Addendum #1

Lewiston Readiness Center Roof Replacement Project
Project No. 23SR10-461-D, Bid Number #16-040

Directorate of Facilities Engineering

5 April 2016

SHEET ID:
 A-107
 SHEET: 10 of 36

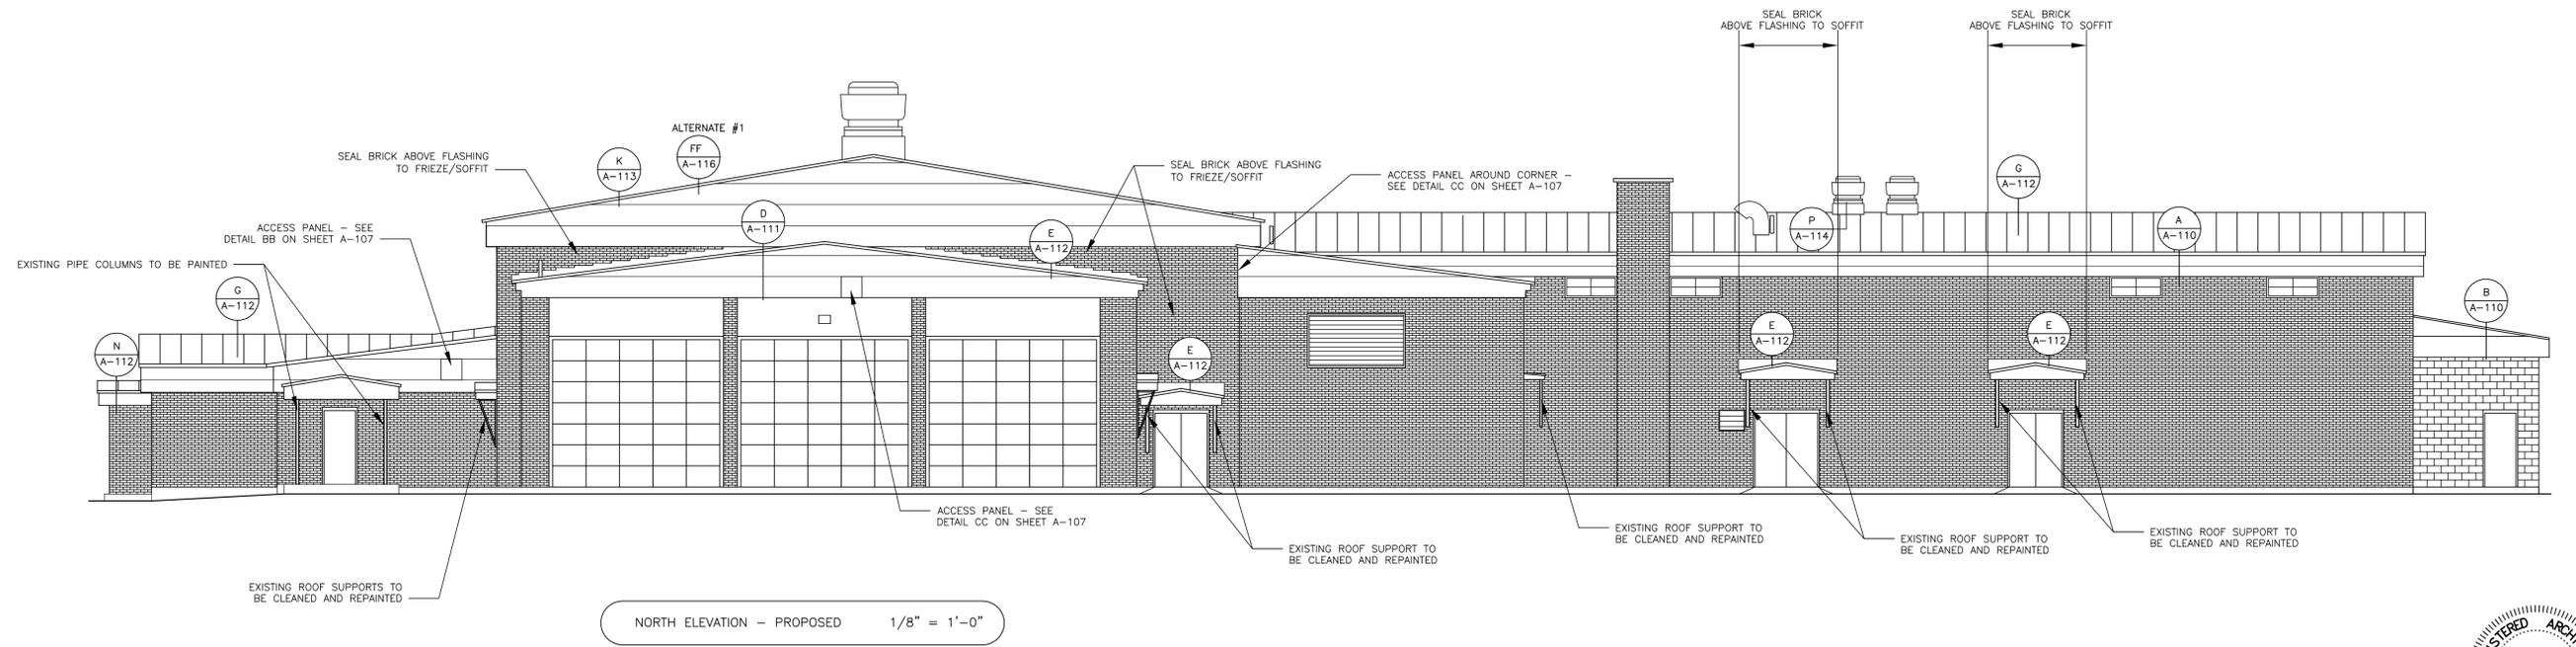
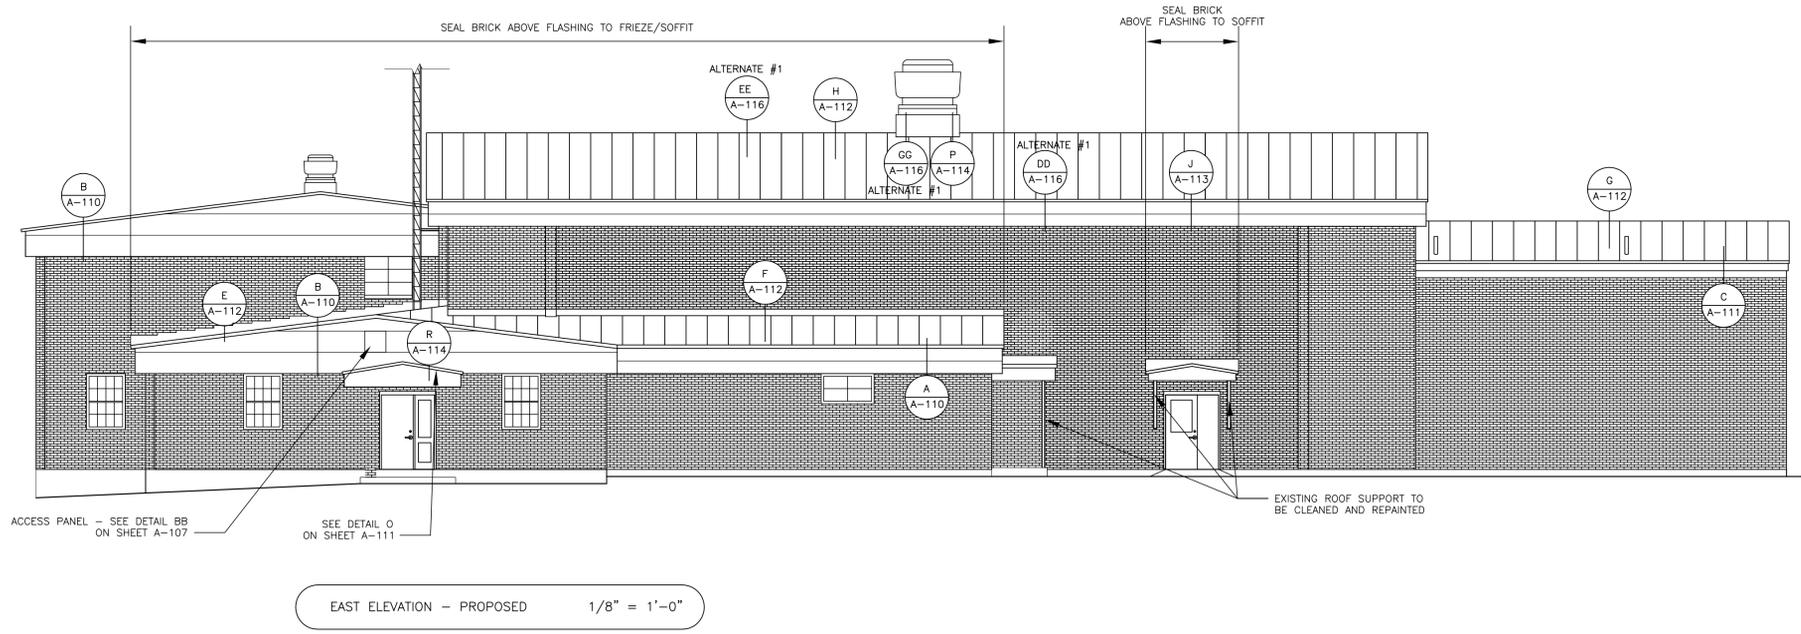
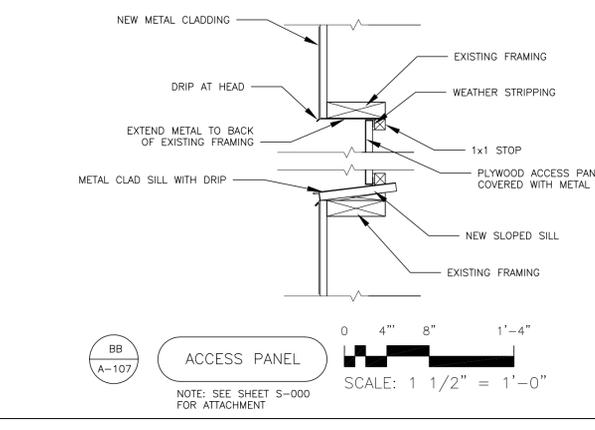
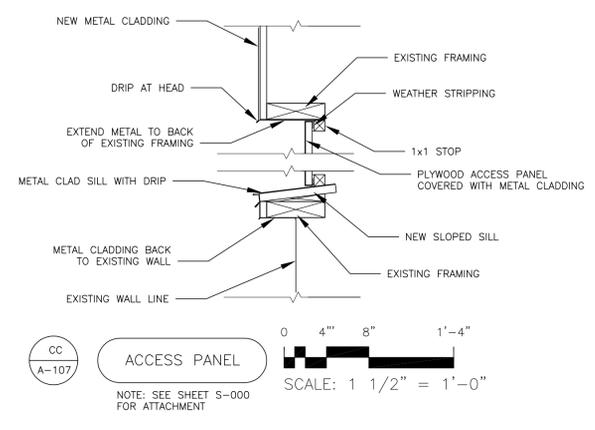
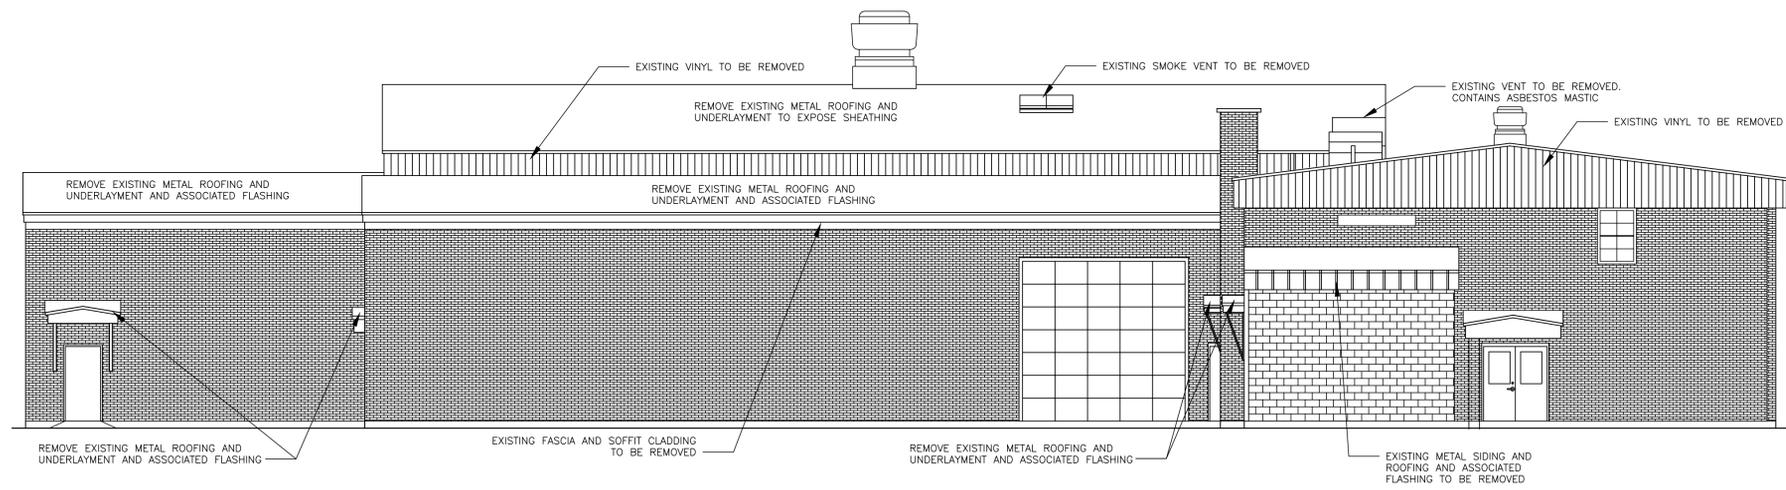
- (6) Sheet A-107: Modified the notes on the canopies not modified under this project to only include the cleaning and painting of the supports and the sealing of the brick above.

SHEET ID:
 A-108
 SHEET: 11 of 36

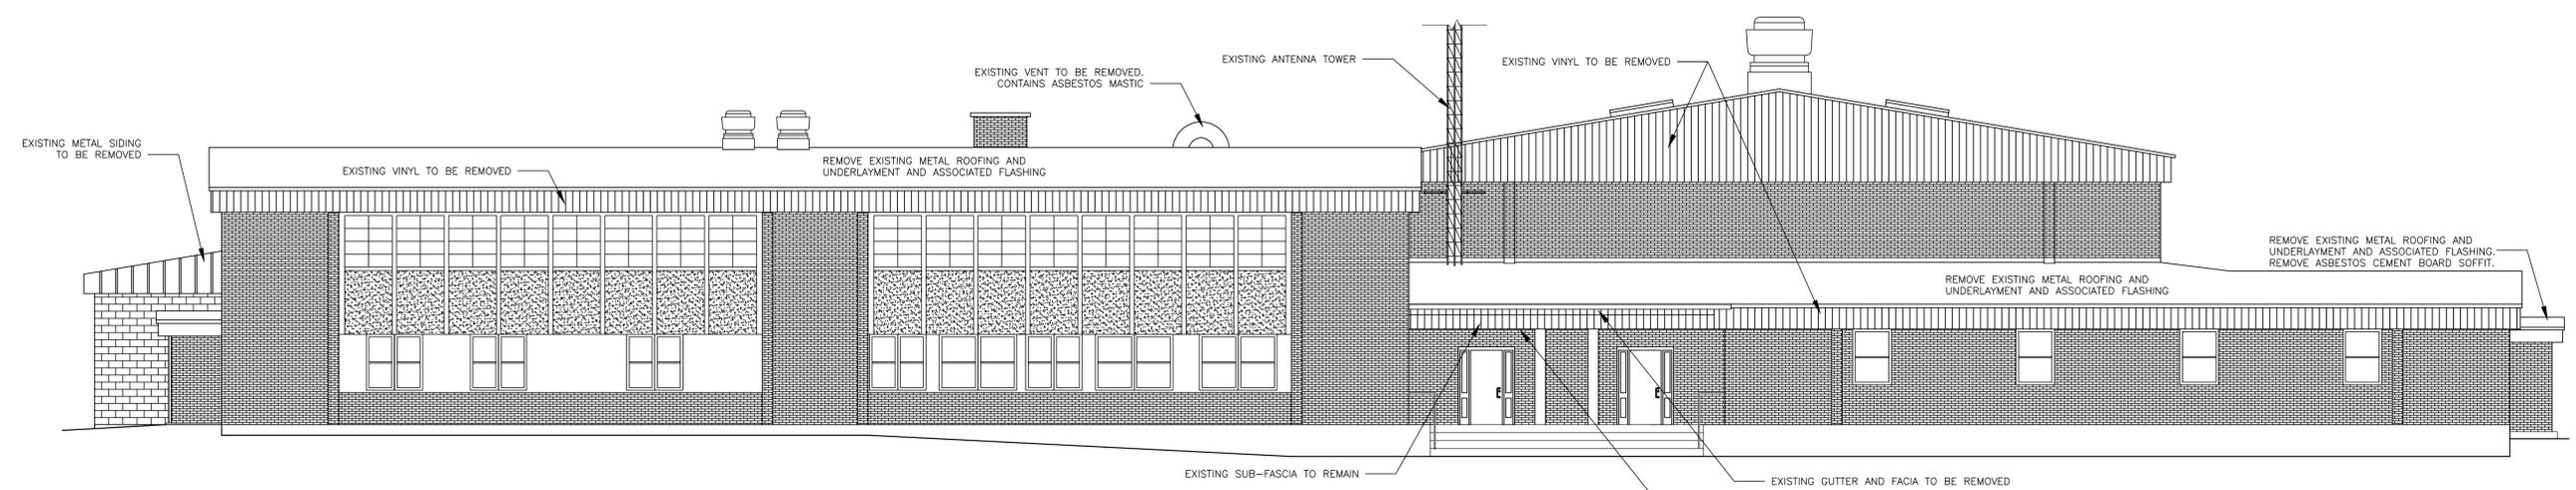
- (7) Sheet A-108: Removed demo notes from canopies to remain under this project.
- (8) Sheet A-109: Modified the notes on the canopies not modified under this project to only include the cleaning and painting of the supports and the sealing of the brick above.

SHEET ID:
 A-110
 SHEET: 13 OF 36

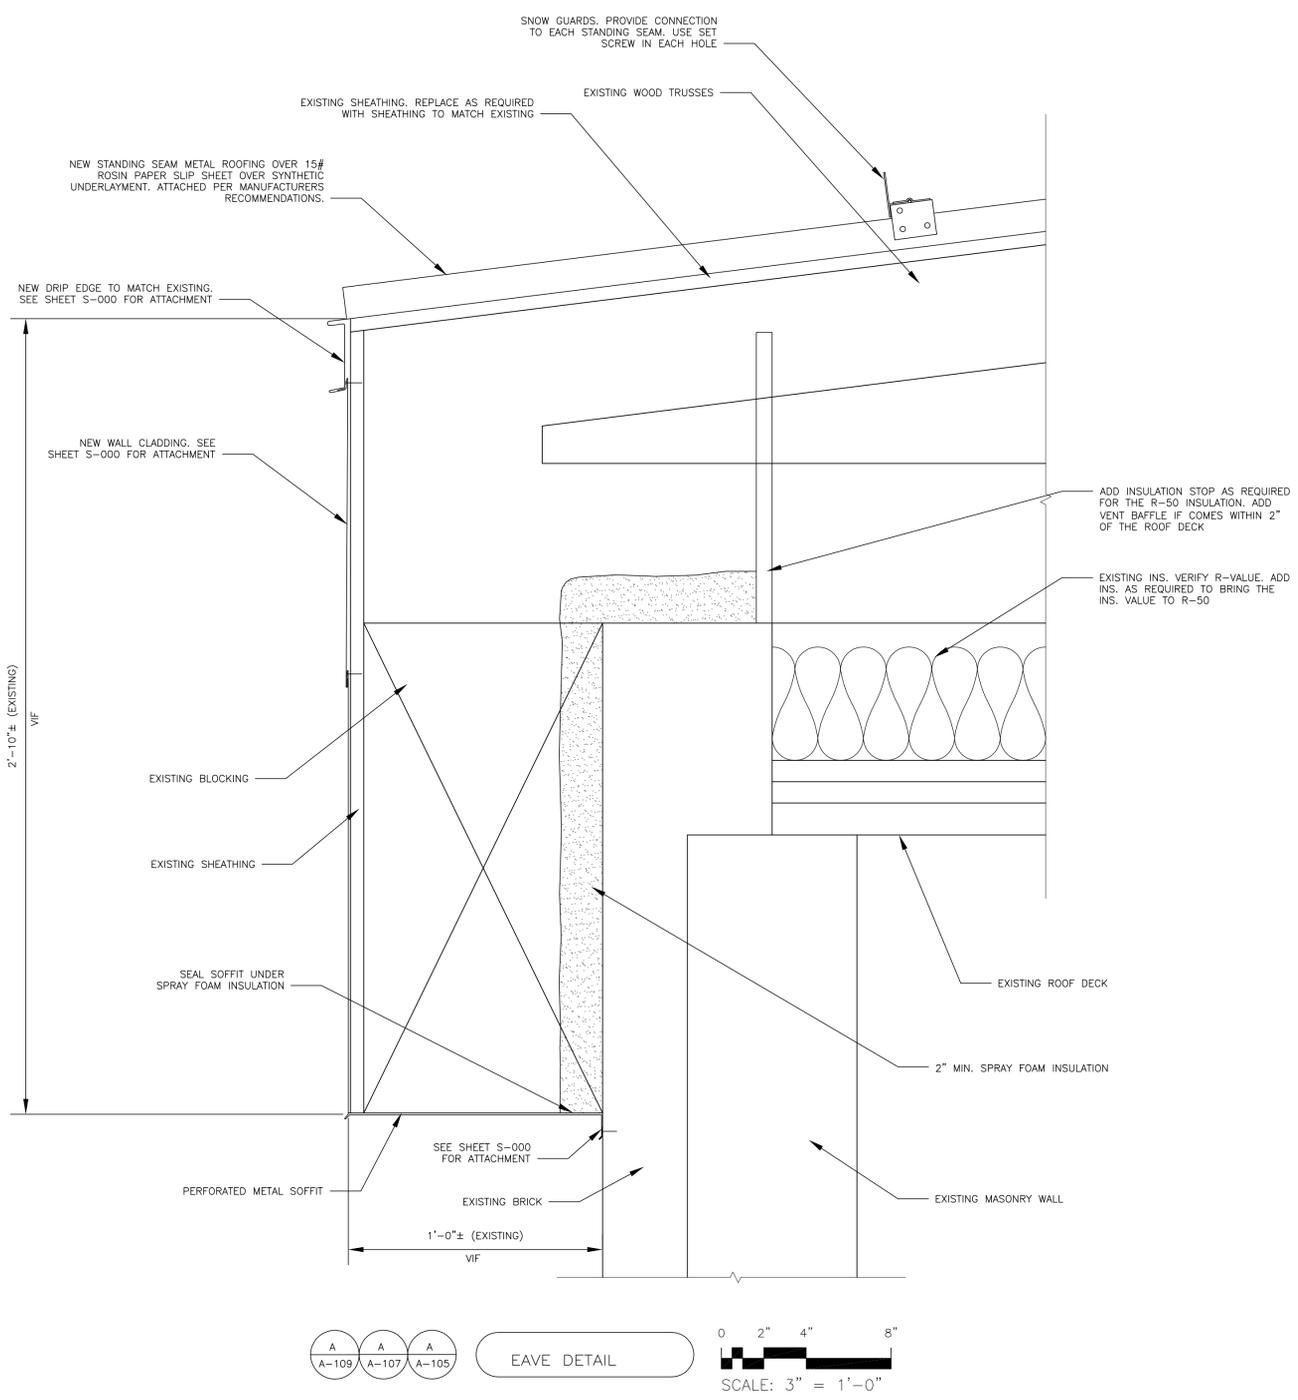
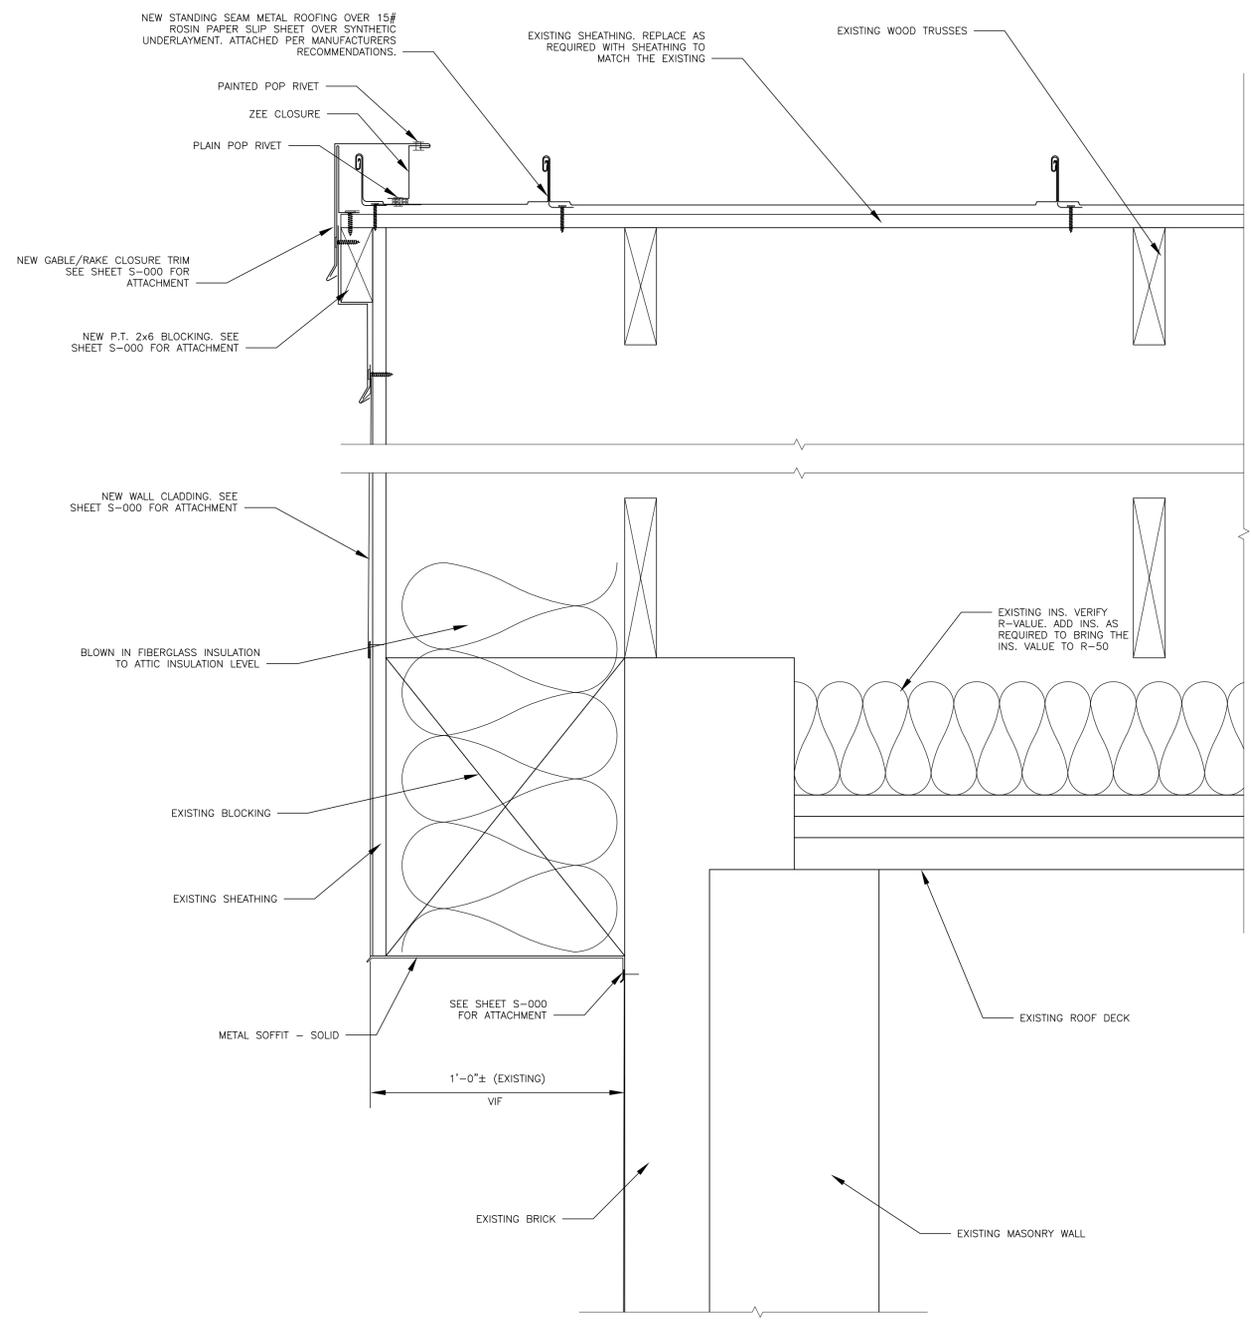
- (9) Sheet A-110: Detail A, Change attic insulation to R-50 and added spray foam insulation to the eave/soffit. Detail B, Change attic insulation to R-50 and added blown-in fiberglass insulation at the gable soffit.
